SERVICE BULLETIN

NUMBER: SB 500-34-001

MODEL: EA 500

SUBJECT: Pitot / Angle Of Attack Probes Upgrade / Retrofit

FIGURE 1

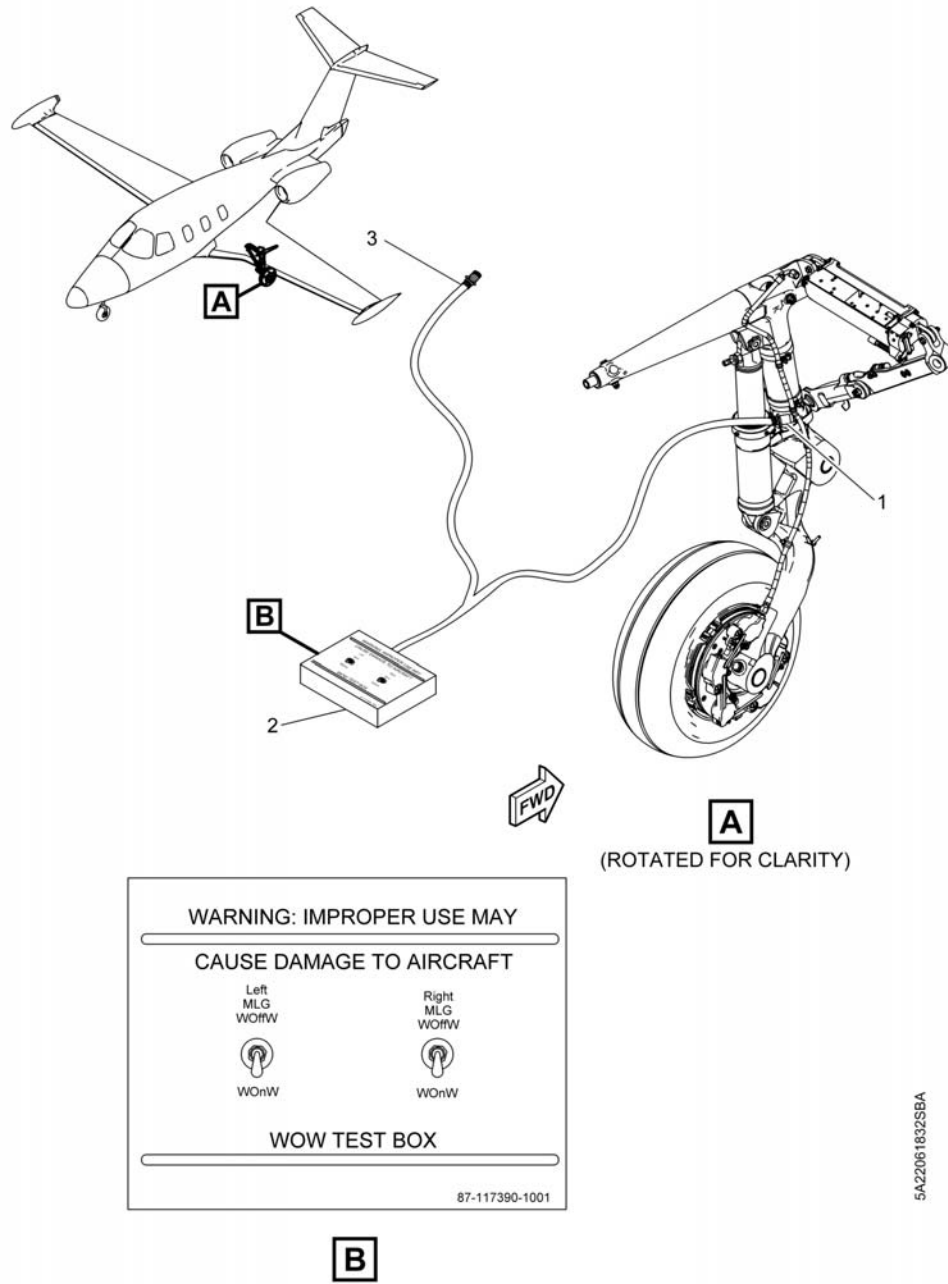
- Disconnect electrical connectors 32A07P01 (left) (1, Fig. 1) and 32A08P01 (right) (3, Fig. 1) from WOW proximity sensors on left and right landing gear.

- Connect WOW Box (2, Fig. 1) to electrical connectors 32A07P01 (left) (1, Fig. 1) and 32A08P01 (right) (3, Fig. 1) on the landing gear.
- Note:** Make sure that the WOW Box switches are set to WOnW.

- q. Disconnect the WOW Box (2, Fig. 1) as follows:
 - Disconnect WOW Box (2, Fig. 1) from electrical connectors 32A07P01 (left) and 32A08P01 right) on left and right landing gear.

- Connect electrical connectors 32A07P01 (left) (1, Fig. 1) and 32A08P01 (right)(3, Fig. 1) to WOW proximity sensors on left and right landing gear.
- (5) Pitot/AOA Probe Heat Test
